Planning & Zoning Commission Regular Meeting

Wednesday, February 12, 2025 at 6:30 PM

AGENDA

SHEET 7 OF 31

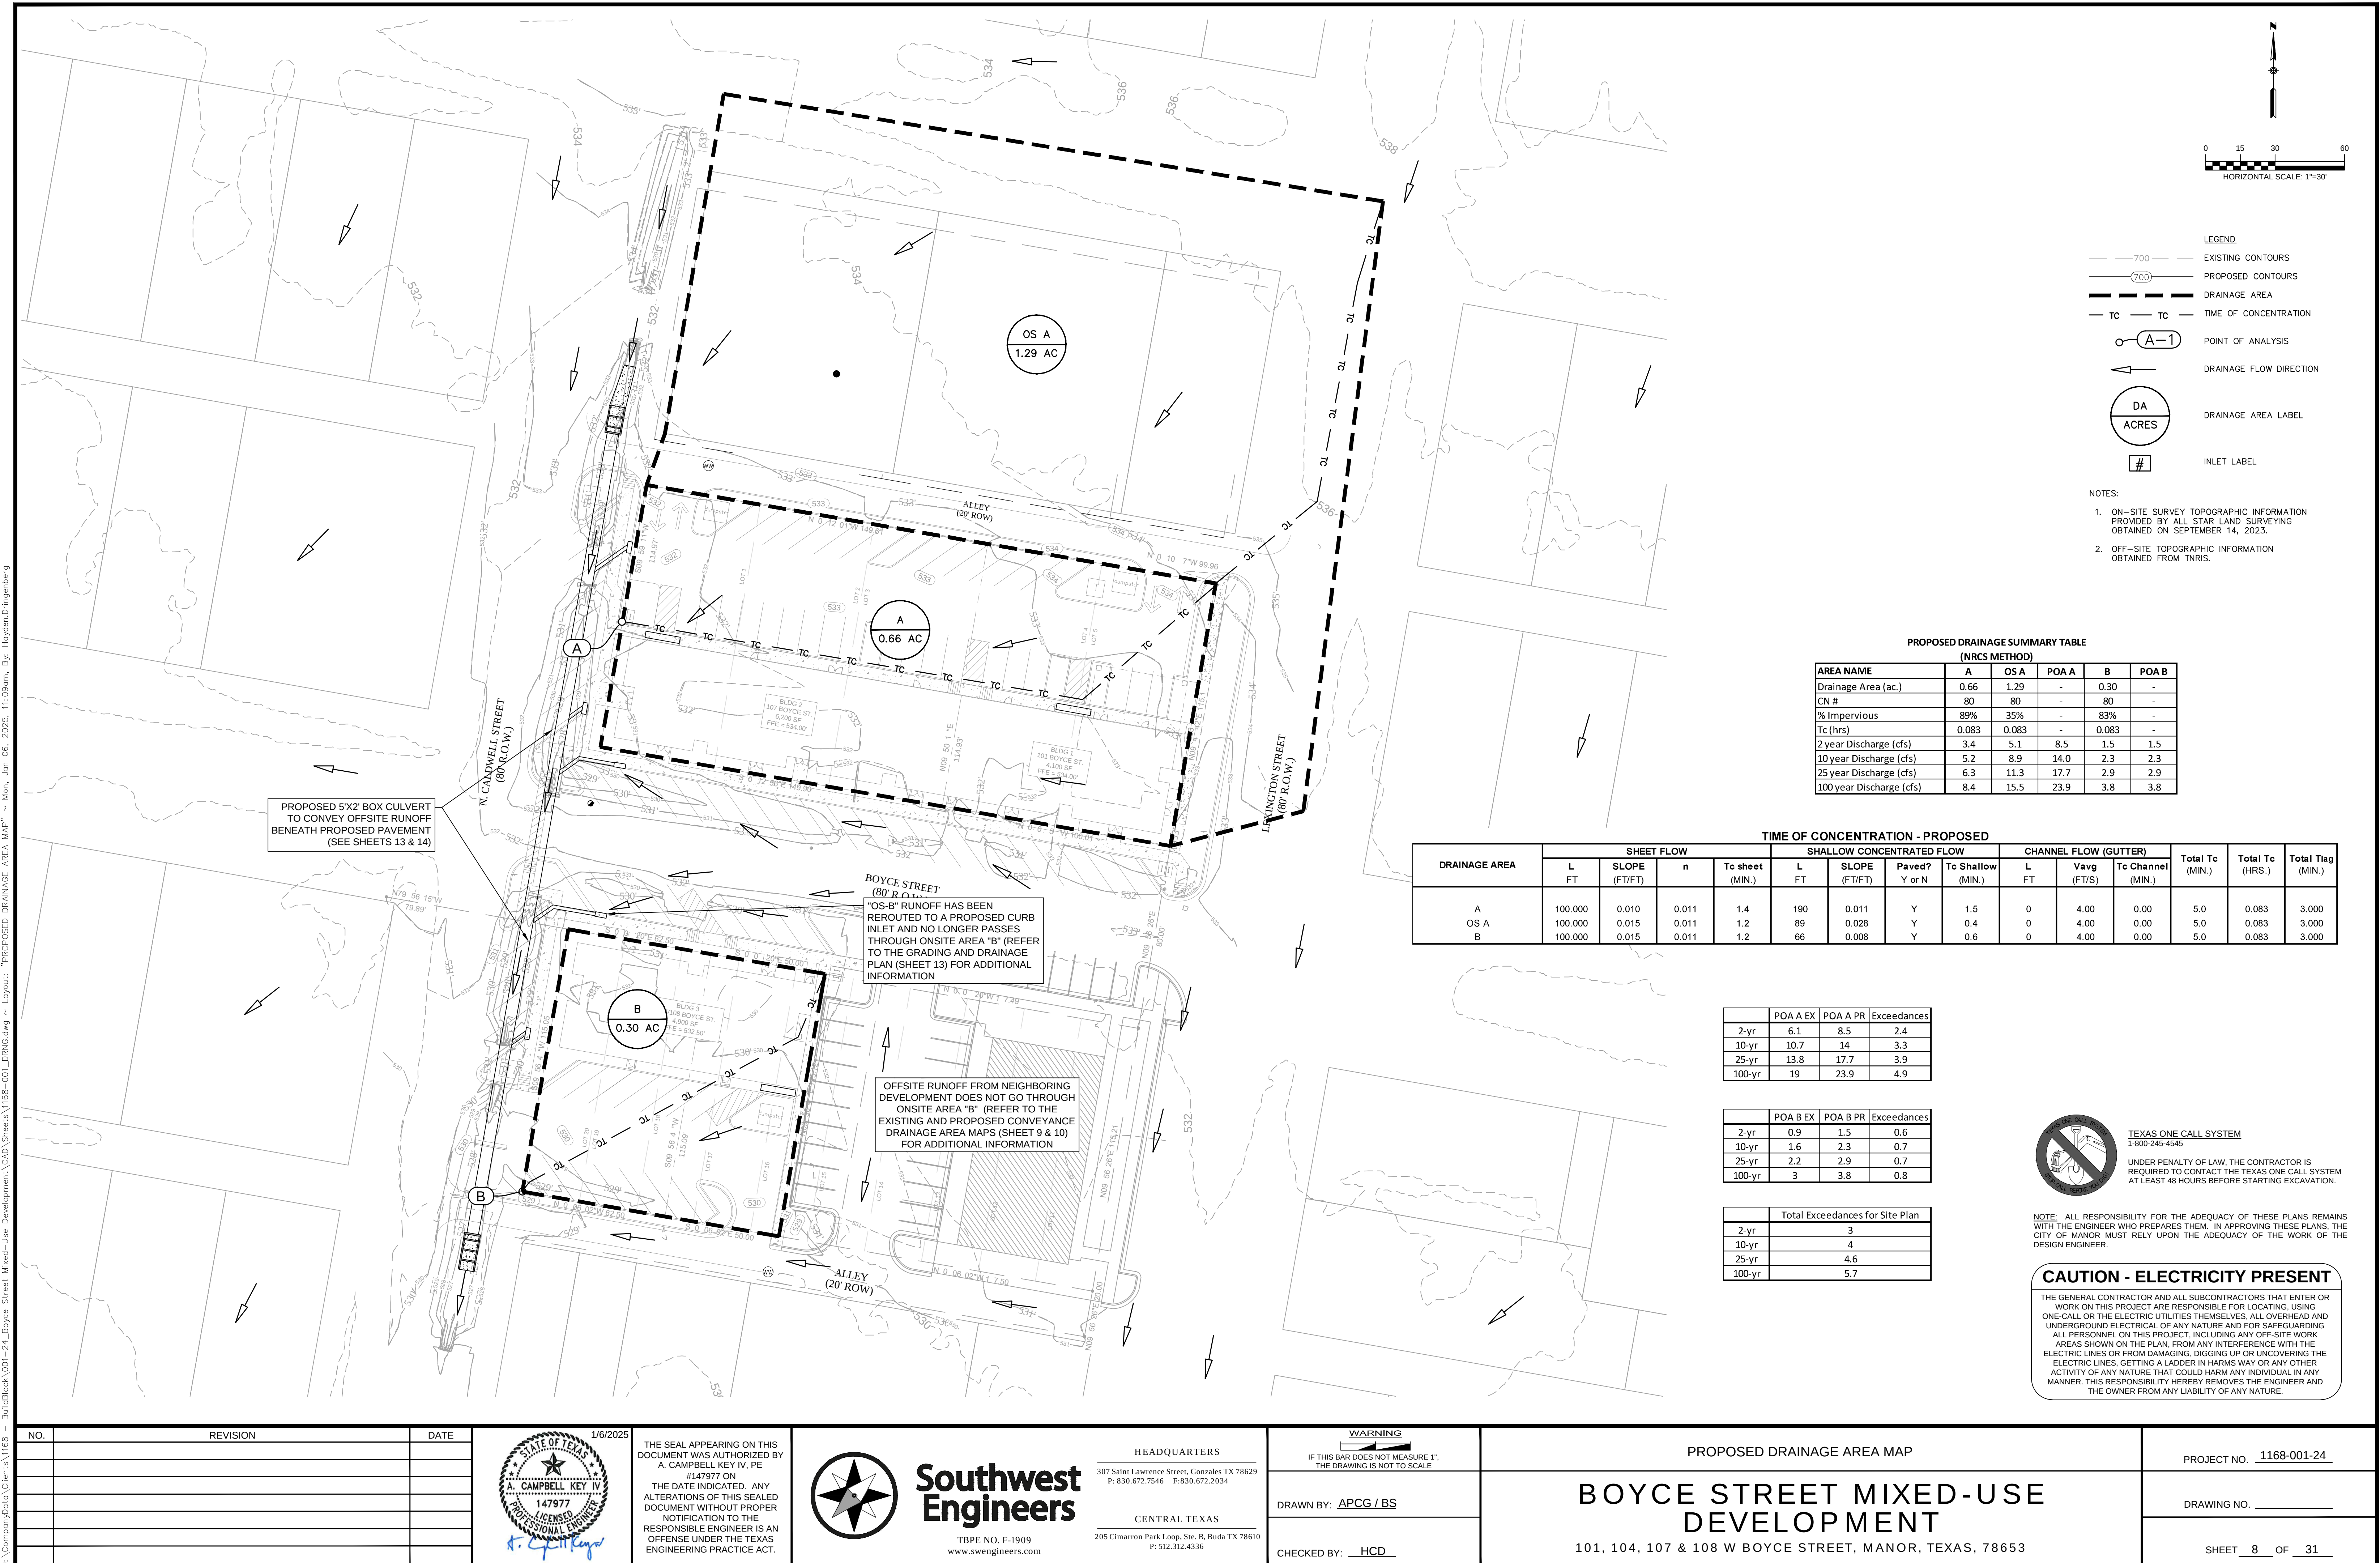
5. On the proposed Drainage Area Map (Sheet 8 of 30), clearly show the proposed storm sewer line. Currently, everything looks in gray scale and it is difficult to distinguish between existing and proposed infrastructure.

- a. Comment remains until all comments are cleared. Language found on cover sheet.**
- ~~5. On the proposed Drainage Area Map (Sheet 8 of 30), clearly show the proposed storm sewer line. Currently, everything looks in gray scale and it is difficult to distinguish between existing and proposed infrastructure.~~

Comment Response: The proposed storm sewer line is now more prominent and shown darker on the Proposed Drainage Area Map (Sheet 8).
